SERVICE TECHNICAL INFORMATION

ONE POINT REPAIR

REF. NO.: SI-98-037

: Interference from FM radio wave on signals recorded using a microphone.

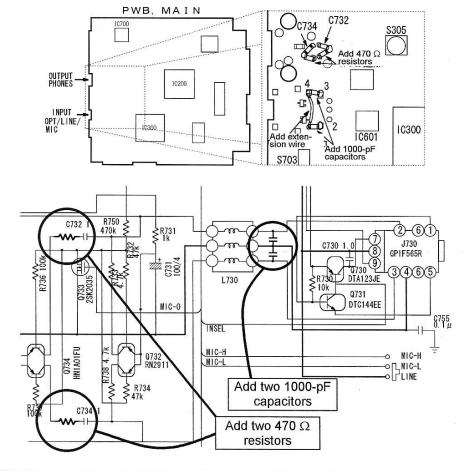
In strong electric field of FM radio wave, interference from the radio wave may occur in

signals recorded using a microphone. Take the following actions against the

symptom.

Add two input-control resistors 470- Ω and two 1000-pF capacitors.

Connect the resistors to the lands of C732 and C734, in series to C732 and C734. Apply the capacitors between pin2 - pin 4, and between pin3 - pin4 of L 730. Add an

extension wire between pin2 - pin4.
